CALIFORNIA'S LOW CARBON FUEL STANDARD

SUPPLEMENT TO THE FINAL STATEMENT OF REASONS

**Comments on and Responses to the Severability Clause and the
Conversion of Midwest Soybeans to Biodiesel and Renewable Diesel**

March 2010

Figure: U.S. Soybean Yield

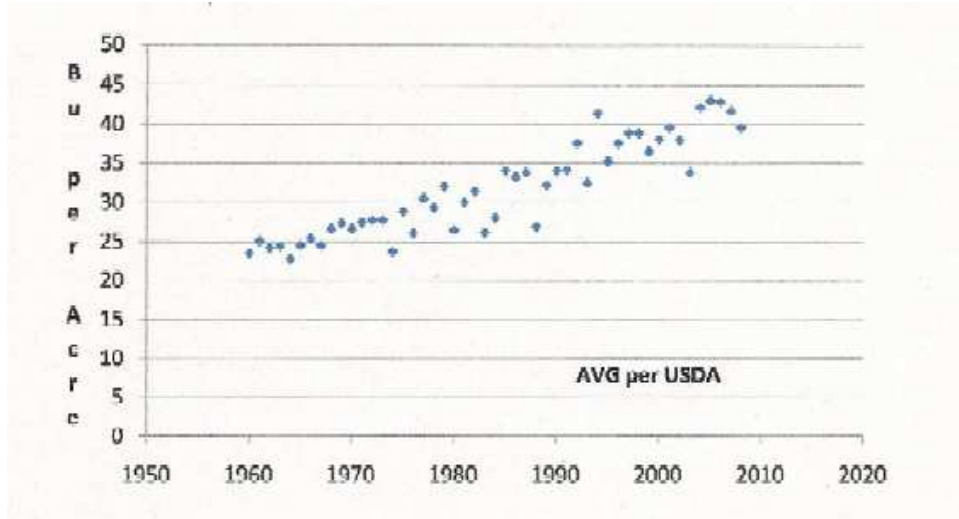
VI-8. Comment: We noticed the comment "Since yields for soybean (three year running averages) have remained relatively stable since the baseline year of 2004, an external adjustment was not necessary for soy biodiesel." Is this a valid assumption? In the United States the average soy bean yield is about 40 bushels per acre and increasing at the rate of about 0.4 bushels per acre per year (See Figure below). There is no reason to assume that soy farmers have reached a maximum yield because the record yield was 139.4 in 2006 and 154.7 bushels per acre in 2007. Would changing this assumption to match long term yield trends result in a lower ILUC factor for soy renewable diesel?
(A2O4NESTE6)

Response: ARB agrees that soybean yields should be adjusted to current levels, in a manner that is consistent with the adjustment performed in the corn ethanol analysis. Such an adjustment was performed for the updated soy biodiesel analysis made available with the Fourth 15-Day Change Notice. In that analysis, the oilseed yield increased by seven percent between 2001 and the three-year average for 2006-2008. Adjusting the GTAP results for this yield increase reduced the soy biodiesel land-use change carbon-intensity from 66 to 62 g CO₂e/MJ.
